Planning Application Ref: AW/71/18/HH

Location: 36 Kingsway, Aldwick

Description of works: Demolition of existing ground floor extensions to front of property, construction of a single storey rear extension and reworking of existing external hard and soft landscaping. This application affects the character and appearance of the Craigweil House Conservation Area.

36 Kingsway, Aldwick

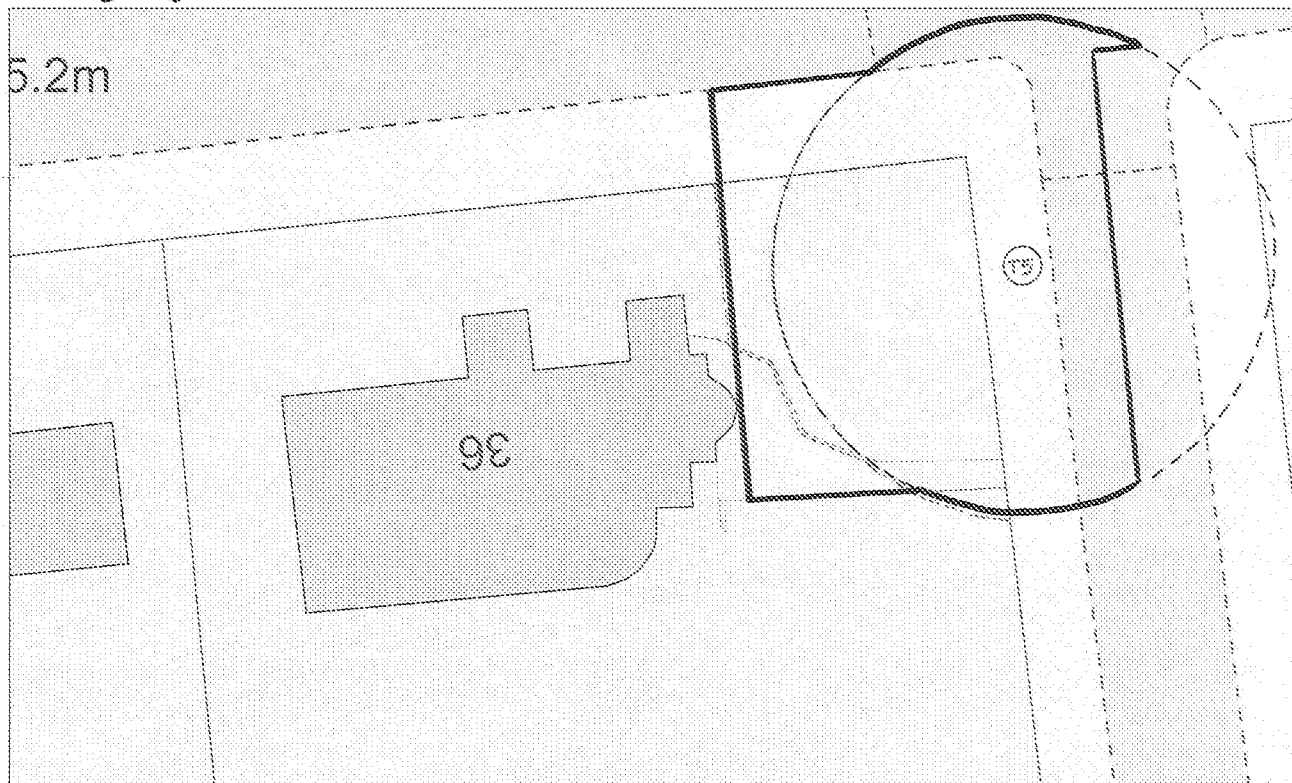
- * I would need to see a revised and asymmetric RPA for T5 that adequately compensates for the impediment to root growth as described earlier, before I could consider lending this scheme my full approval. This will require the re-positioning of the second driveway access further west; an alternative 'No-dig' method of construction in the proposed position would demand ground level changes that are unlikely to be acceptable to the applicant. All parties have agreed that ground level changes necessary to accommodate the proposed 'No-dig' solution within the curtilage of the property are achievable and tolerable. As such the original proposed location of the new driveway access is acceptable. I accept the specification as detailed in Cellweb Section -- Tree Root Protection drawing no. GS-CW-BP-75 is adequate for its intended use.

- * I attach an indicative plan showing the desired RPA outcome for T5 to be adopted in a revised plan drawing, which can better inform a design. If necessary, I would be happy to meet the applicant's agent to discuss the methodology and measurements that support this plan. Site meeting with Arboricultural Consultant, Architect and Residents held on 3rd July 2018.

Tree Protection Boundary - minimum extent
Recommended Root Protection Area (RPA)
Uniform RPA - not recommended
